## Grandview Reserve Phase 2 Preliminary Drainage Report

December 2023

HR Green Development, LLC

EDARP Filing No.:  
PUDSP236

## APPENDIX D – WATER QUALITY & DETENTION

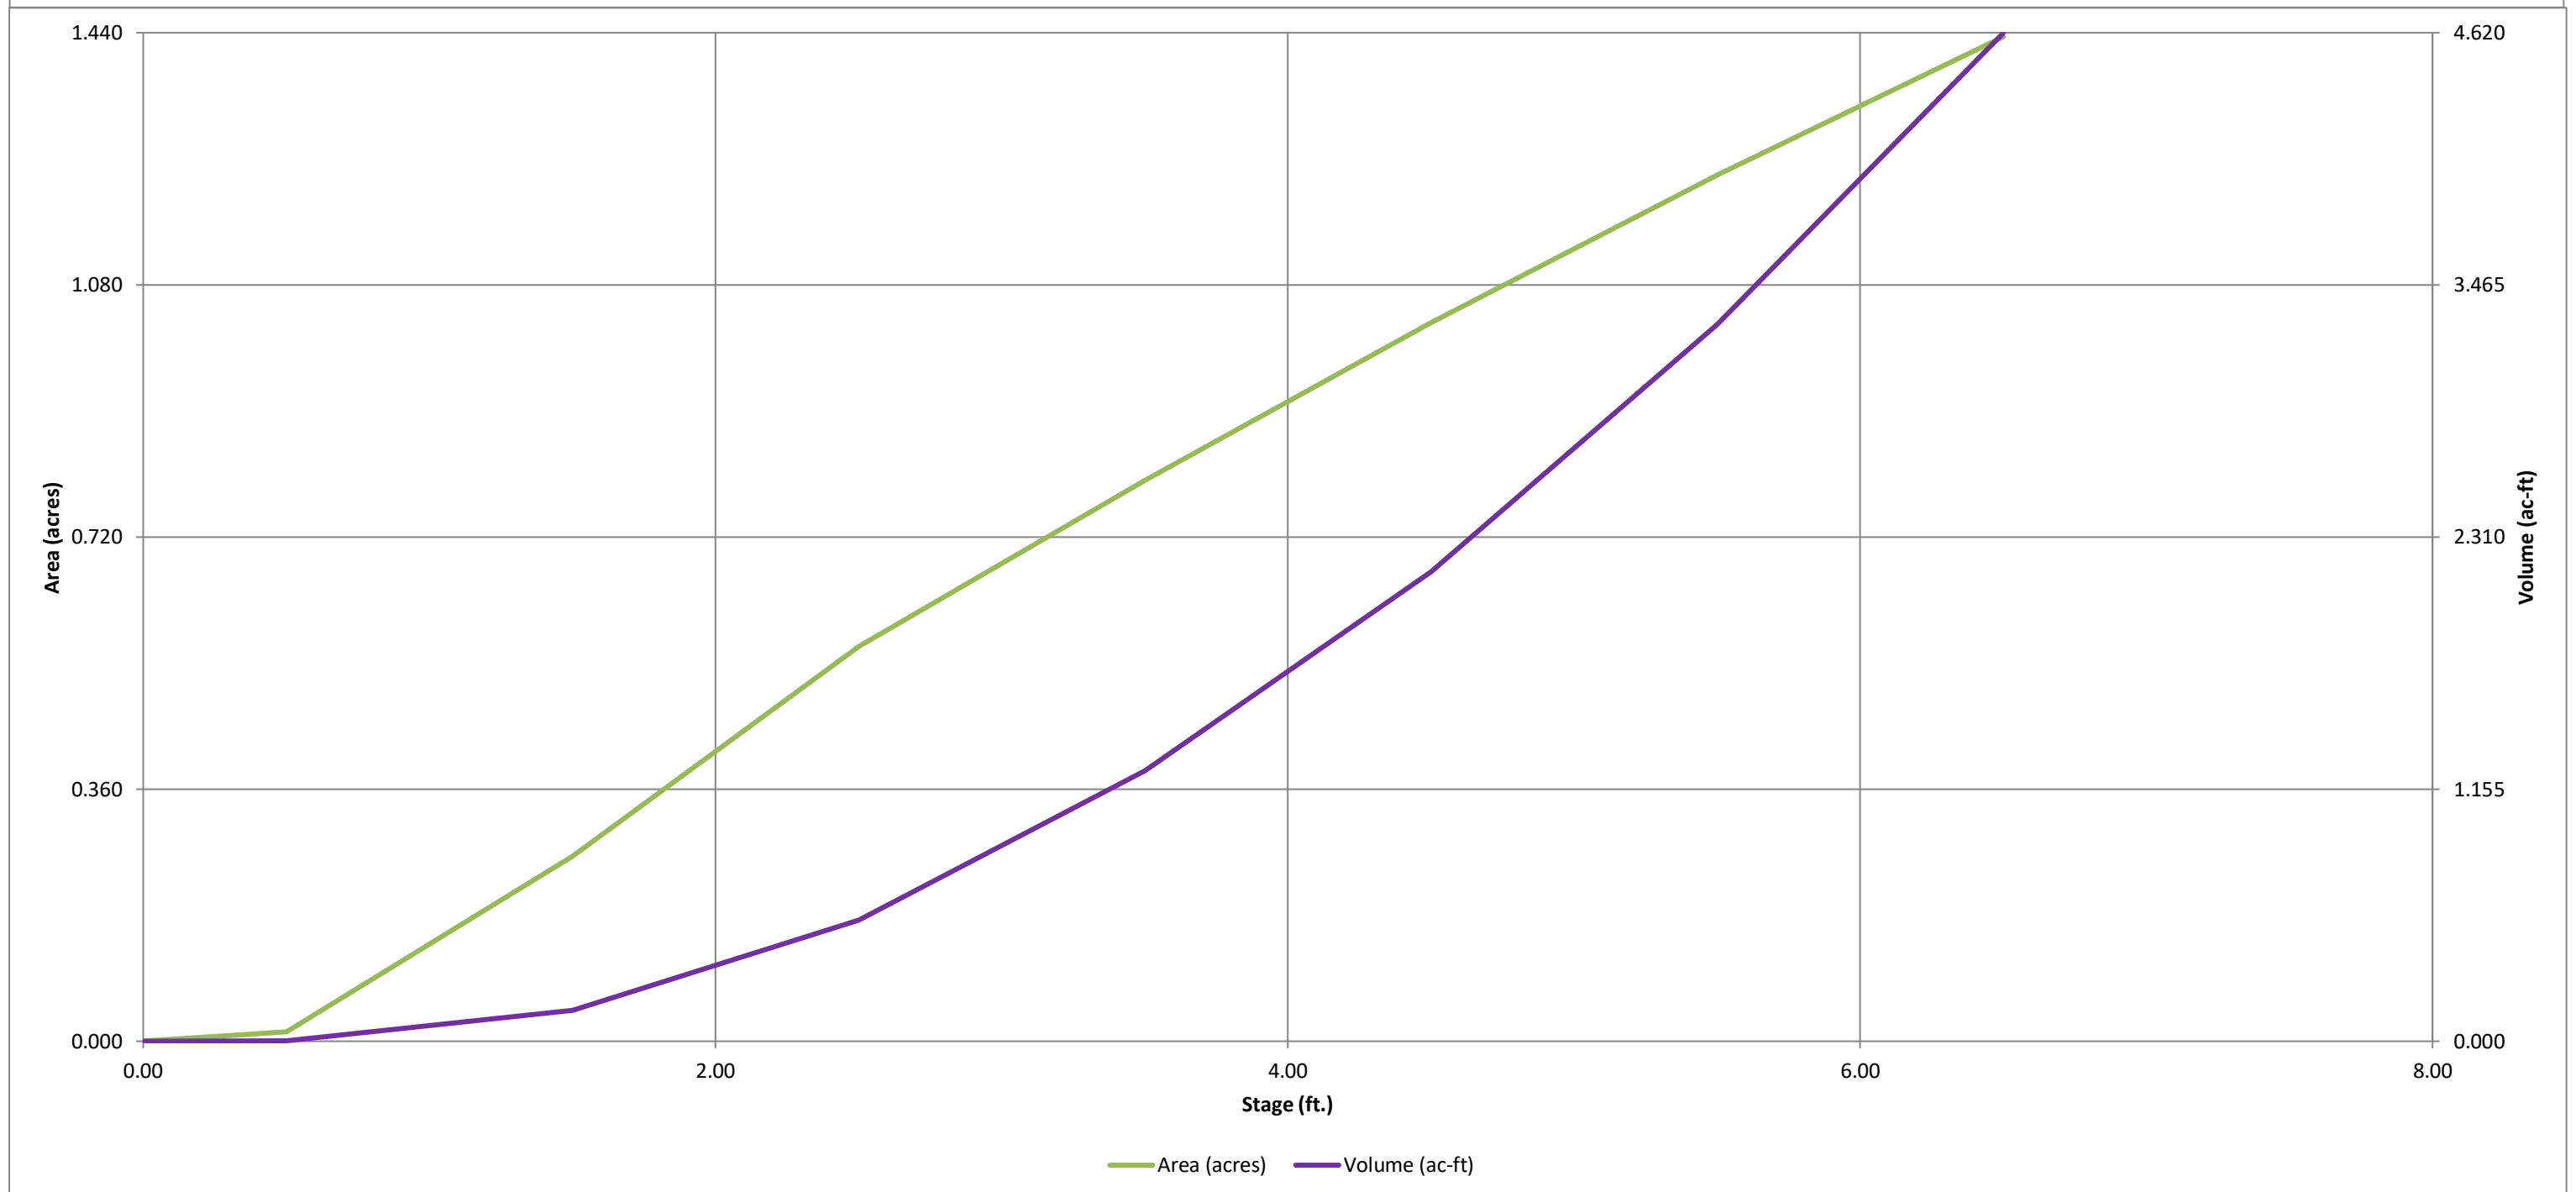
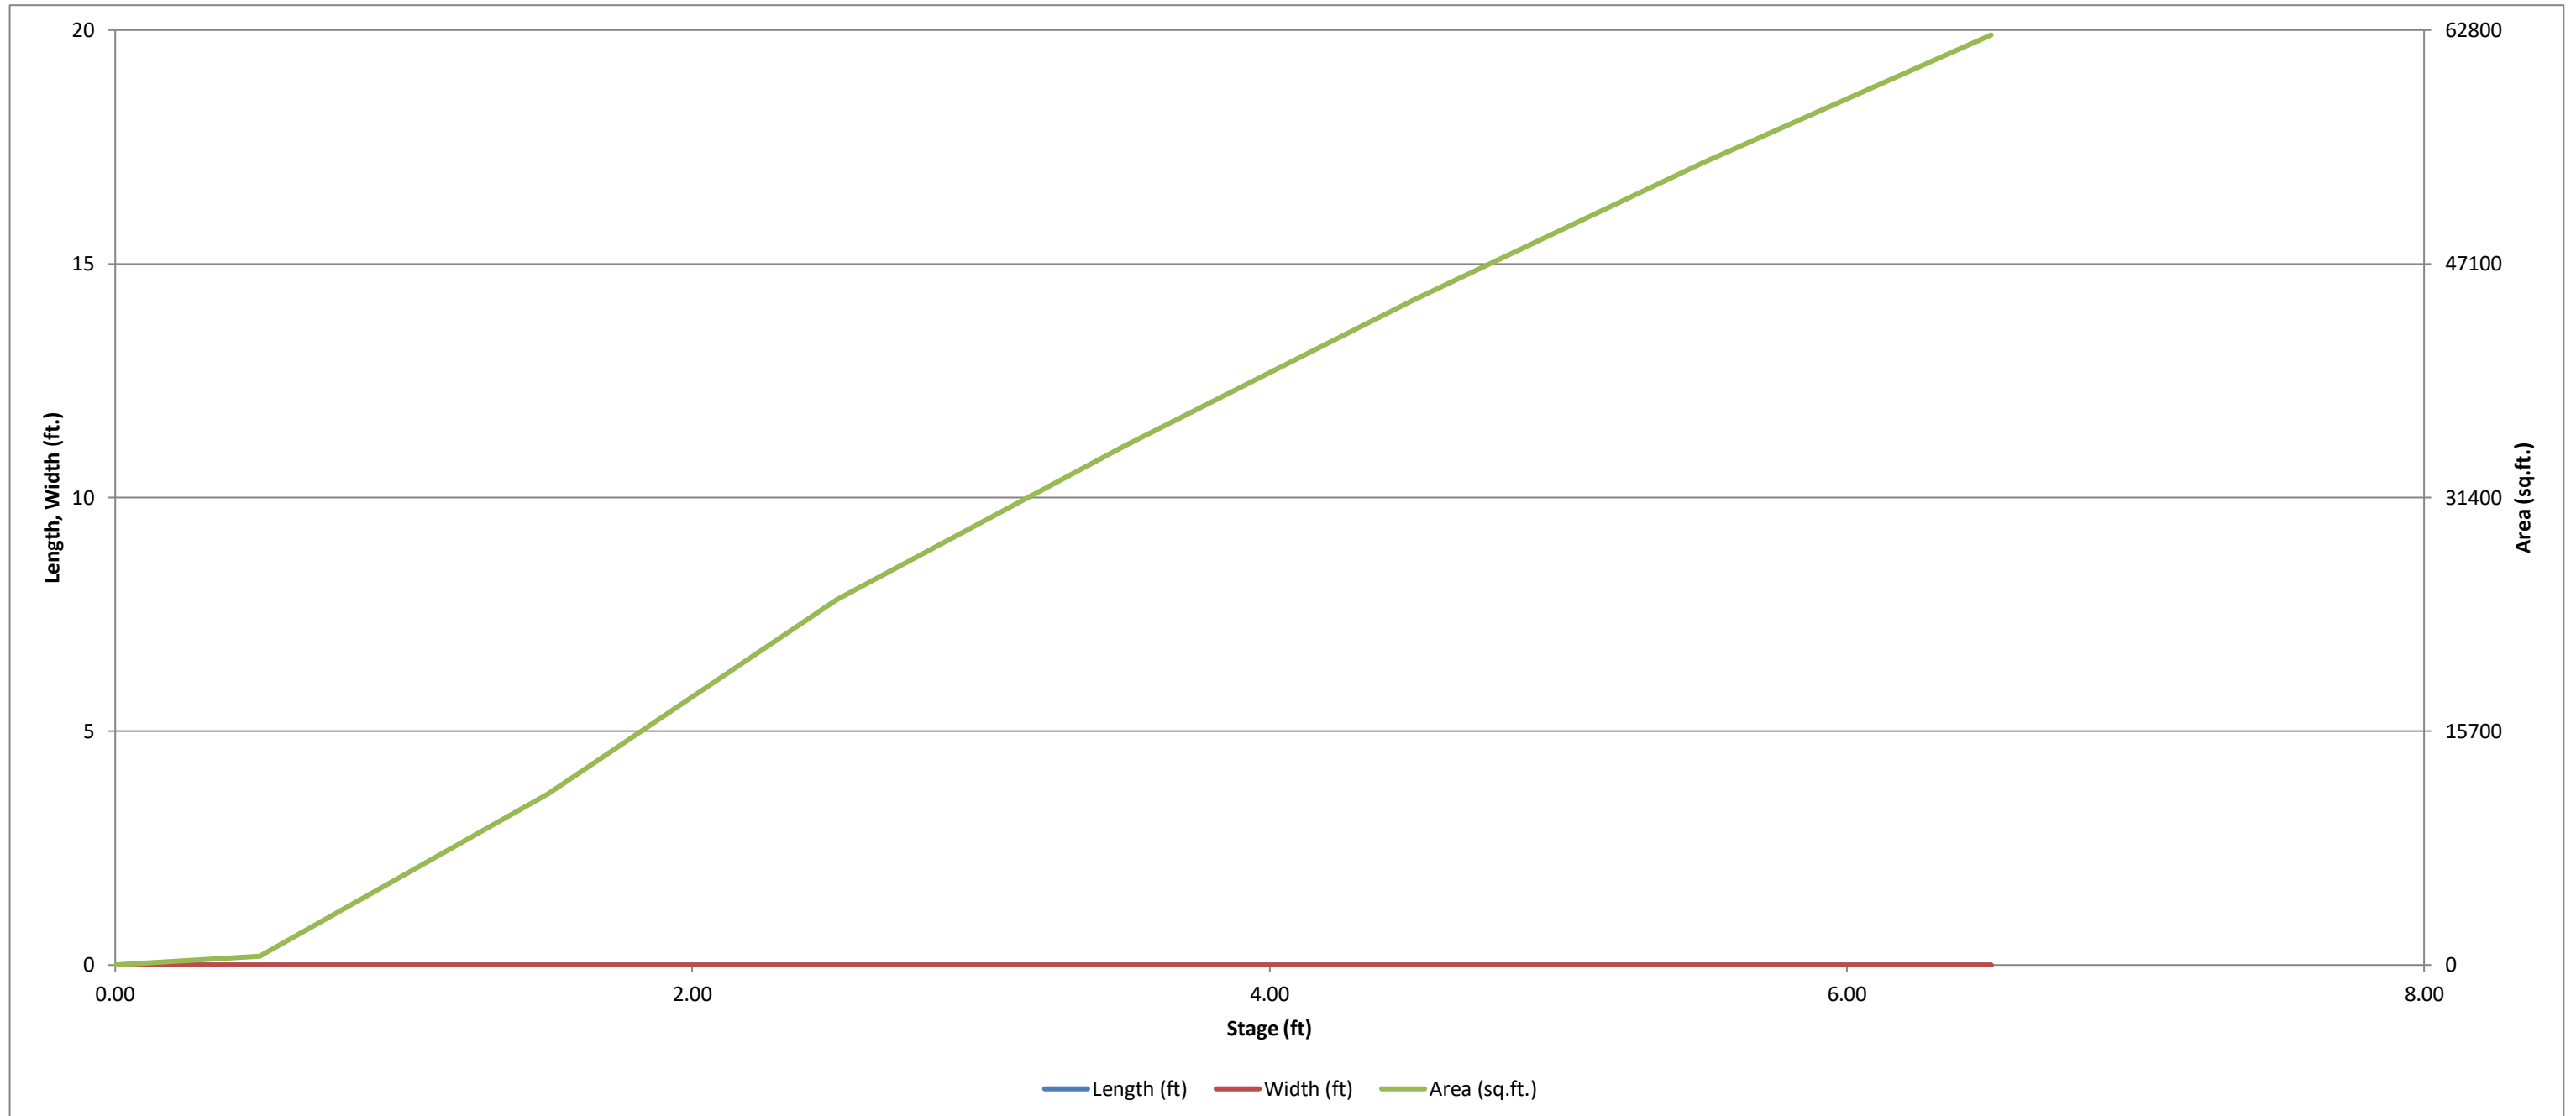
Note that the pond calcs will be reviewed in more detail with the FDR and subsequent submission of CDs. Can't do a full review of these calcs without the pond details in the CDs.

HR GREEN RESPONSE:  
NOTED.
